**Re: Response to ADEQ Correspondence Dated July 15, 2015
Whirlpool Response to ADEQ May 20, 2015 Letter
Fourth Quarter 2014 Progress Report
Whirlpool Facility - Fort Smith, Arkansas
EPA No. ARD042755389
AFIN No. 66-00048
CAO LIS 13-202**

Date August 4, 2015

STATIC WATER LEVELS

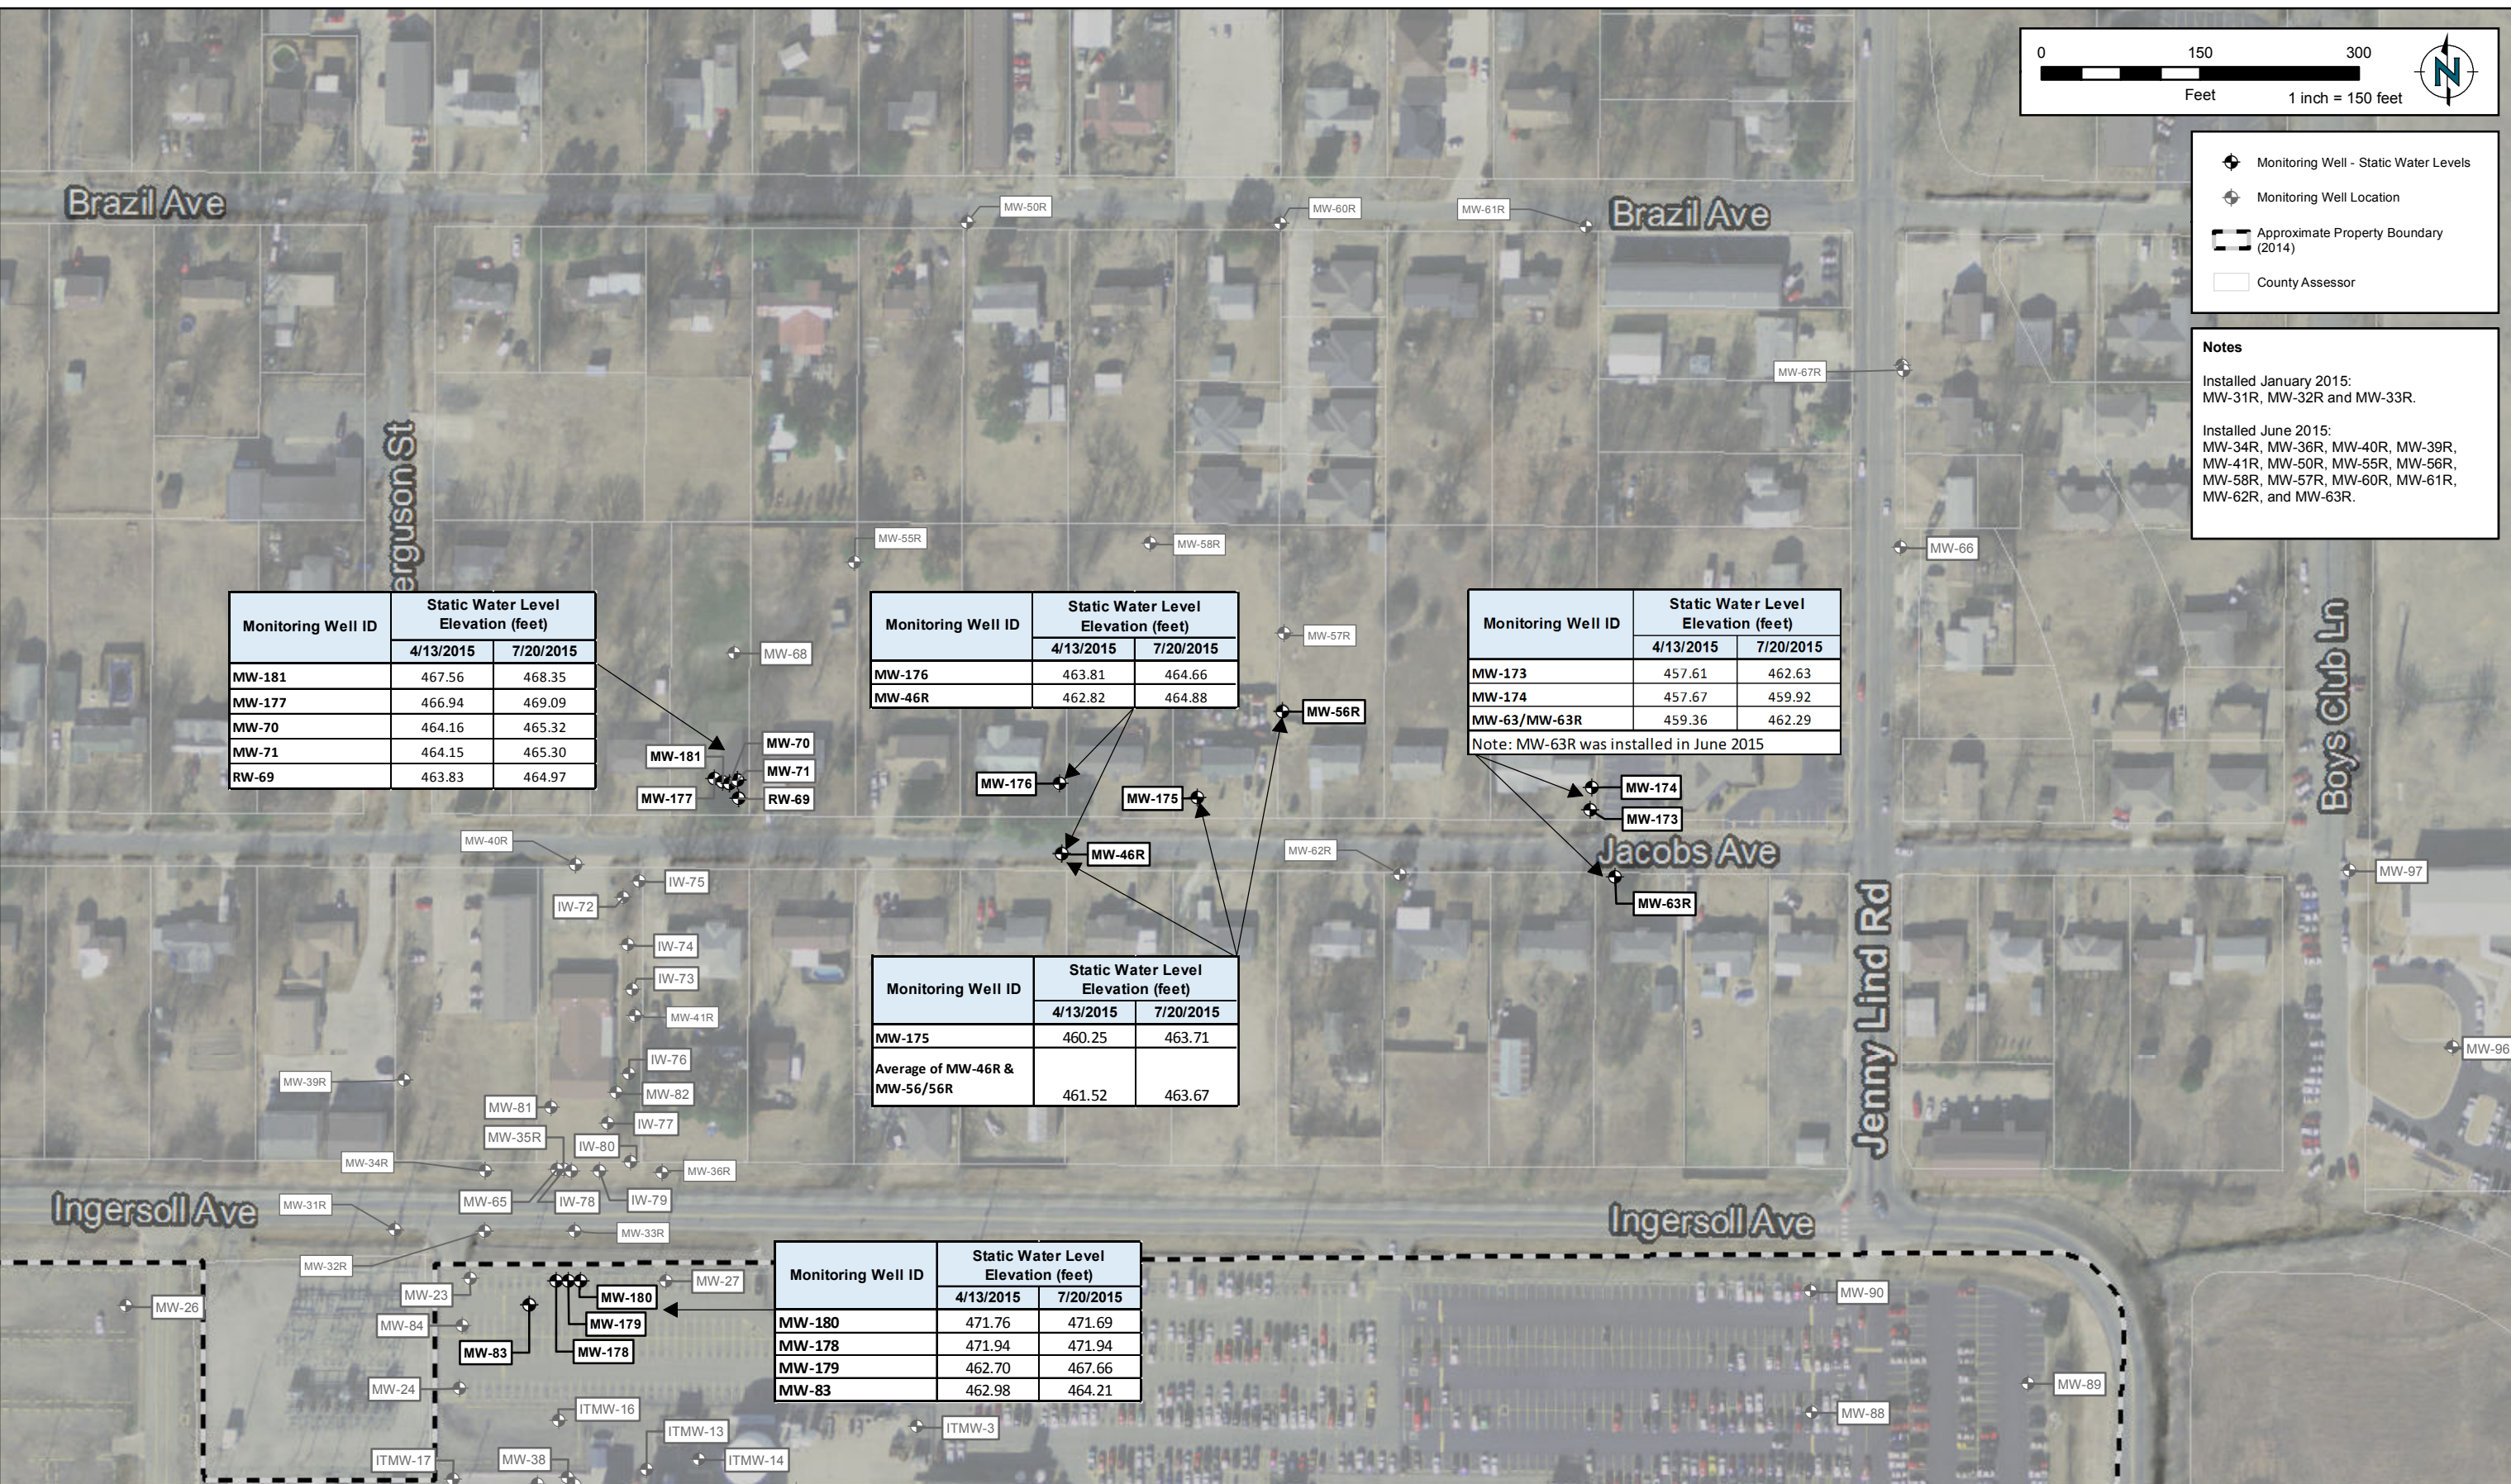
2. *The direction of vertical hydraulic gradient between the basal aquifer and the overlying silty-sand interval in the western portion of the northern plume. Original comment: "No evidence was provided to support the assertion that groundwater flow would be upward from the basal aquifer to the silty-sand interval. Comparisons should be made between groundwater elevations in deep wells and associated shallow wells to determine the direction and magnitude of the vertical hydraulic gradient. This comparison should be made on a quarterly basis in order to evaluate both vertical migration and seasonal variation. Please include this comparison in future reports."*

Groundwater elevations measured during the second and third quarter 2015 groundwater monitoring events at shallow groundwater wells MW-173 through MW-177 and MW-181 located along the north side of Jacobs Avenue and MW-178 through MW-180 located immediately south of Ingersoll Avenue were compared to groundwater elevations at nearby deeper monitoring wells to evaluate vertical gradient. Although shallow groundwater monitoring well MW-175 is not located near an associated deeper groundwater monitoring well, it is located approximately at the midpoint between deeper groundwater monitoring wells MW-46R and MW-56 allowing for a comparison between elevations at MW-175 and the combined average elevations at MW-46R and MW-56. Figure 1 presents the static groundwater elevations for the wells included in this evaluation.

Groundwater elevations from shallow groundwater wells MW-173 through MW-177 and MW-181 located along the north side of Jacobs Avenue and MW-178 through MW-180 located immediately south of Ingersoll Avenue decrease from west to east; from a high at MW-177/181 to a low at MW-173/174. The highest shallow groundwater elevations were measured MW-178, MW-179 and MW-180. These results suggest that the direction of shallow groundwater flow mimics the deeper groundwater flow direction to the east/northeast. The number and location of shallow groundwater monitoring wells limit this interpretation.
